Our Reference: P23159

Re: Tealing Solar Development Flood Risk and Drainage Assessment

Please find below our responses to queries raised by the local community group pertaining to the Flood Risk and Drainage Assessment (FRDA) completed by ourselves for the Tealing Solar Development in 2022.

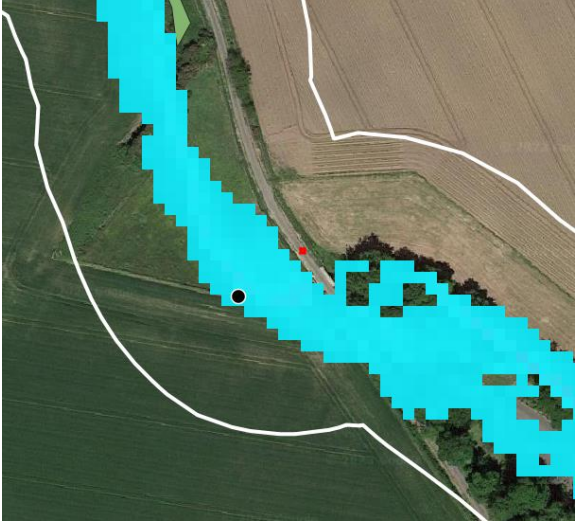
Query Raised	Gavia Response (14/05/2023)
<p>There is significant risk of flooding, particularly in relation to the North-East area of plot 4 where severe flooding took place in November 2022.</p>	<p>The photographs showing the flooding upstream of the minor road bridge (referred to as NE corner of Plot 4) would appear consistent with the modelling outcomes. The 1 in 200 year event is similar in terms of flows to the 1 in 100 year as the event is indicated to show (Table 2 of the FRDA – 5.68m³/s vs 4.76m³/s), therefore is discussed for comparative purposes. The outputs from the model during the 1 in 200 year event (Figure 3 of the FRDA) show a width of flooding in the region of 65m along the road. Flood levels in the photographs would appear to reach a larger rounded fence post to the east of the bridge where several pallets create a boundary to the watercourse. This feature can be detected from aerial imagery, and the modelled flood extents for the 1 in 200 event actually extend a further 10m east along this fence line (hence go to a greater depth). Furthermore, it is highlighted that in the 2D model, flows bypass the bridge structure i.e. it</p>

Query Raised	Gavia Response (14/05/2023)
	<p>shown as a full blockage in the LiDAR, therefore incorporating the bridge would likely only reduce the modelled flooding in this area.</p>  <p>Diagram 1: Modelled flood depths during the 1 in 200 at NE corner of plot 4, the black dot indicates the flood extent from photographs provided, whilst the white line represent the 50m exclusion zone around the watercourse (no solar infrastructure will be placed within this exclusion zone).</p> <p>The photographs around Kellas are outwith the model domain and therefore cannot be verified with the model.</p> <p>It is noted that the SEPA flood maps indicate that 'Plot 5' has localised pluvial flooding at topographic low points. As discussed in Section 4.9 of the FRDA, solar panels will be raised above ground levels and are not considered to be sensitive to the localised shallow surface water flooding indicated by the SEPA flood maps. Overland flow pathways will also be maintained as solar panels will be mounted. Measure to mitigate against impacts on runoff are outlined in Section 8 of the FRDA.</p> <p>It is also highlighted that a 50m exclusion zone around watercourses has been implemented as shown Figure 7, giving a 100m strip of land around the watercourse where no development will occur (see Diagram 1 above).</p>
